Re: In the Matter of Texas Utilities Electric Company, et al
(Comanche Peak Steam Electric Station, Units 1 and 2)
Docket Nos. 50-445-1 and 50-446-1
Supplementation of Applicants' Response to CASE's Request
for Production

Enclosed is the report of the Management Quality Assurance Audit conducted for Texas Utilities Generating Company.

Subject: Audit of Texas Utilities Generating Company, Dallas Offices and Comanche Peak Steam Electric Station Construction Site

EXHIBIT 1

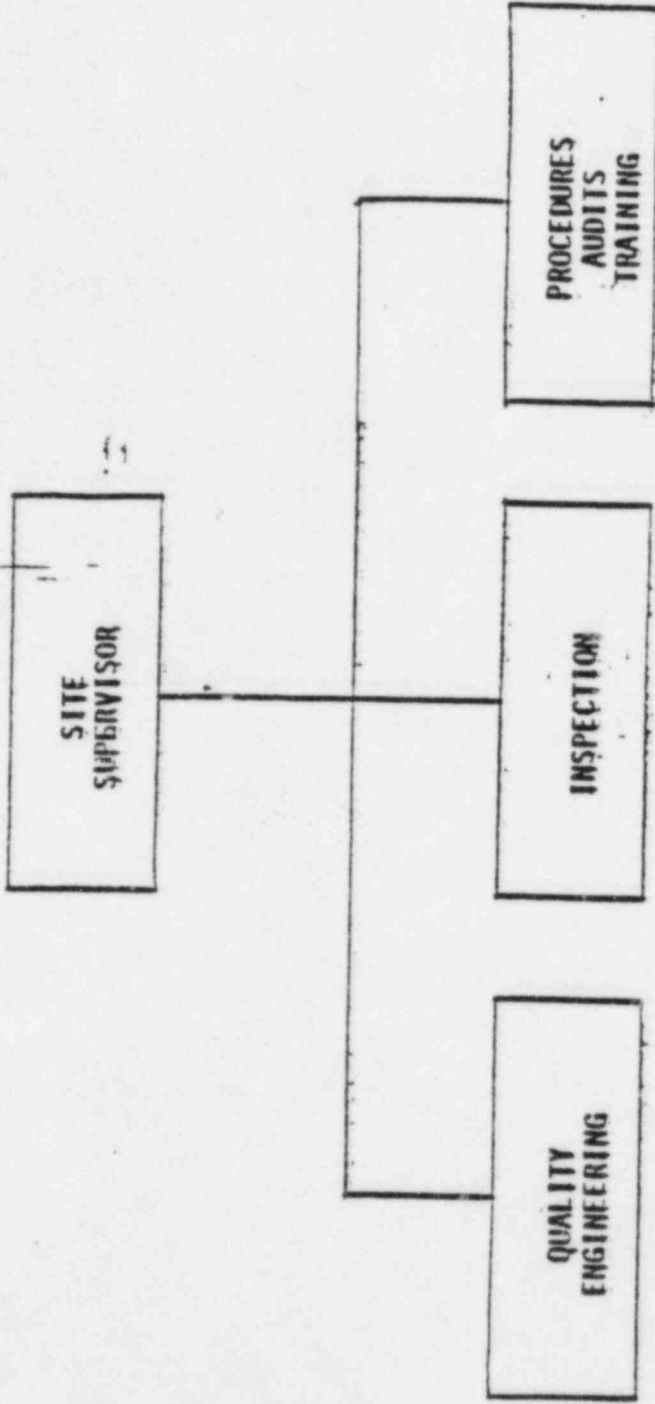
It is recommended that TUGCO adopt an organizational realignment of activities as set forth in Exhibit I, whereby Quality Engineering and Inspection report to the Site QA Supervisor as two separate sub-organizational entities with responsibilities as defined in Exhibit I. Such an organization will better supplement the existing Construction organization and will permit better organization for handling day-to-day site problems as well as implementing recommendations of this report. This is particularly so in the area of inspection planning.

Recommendation: Separate inspection from Quality Engineering (planning).

Response: We had begun work on this before the audit. Our product assurance group has taken responsibility for Quality Engineering.
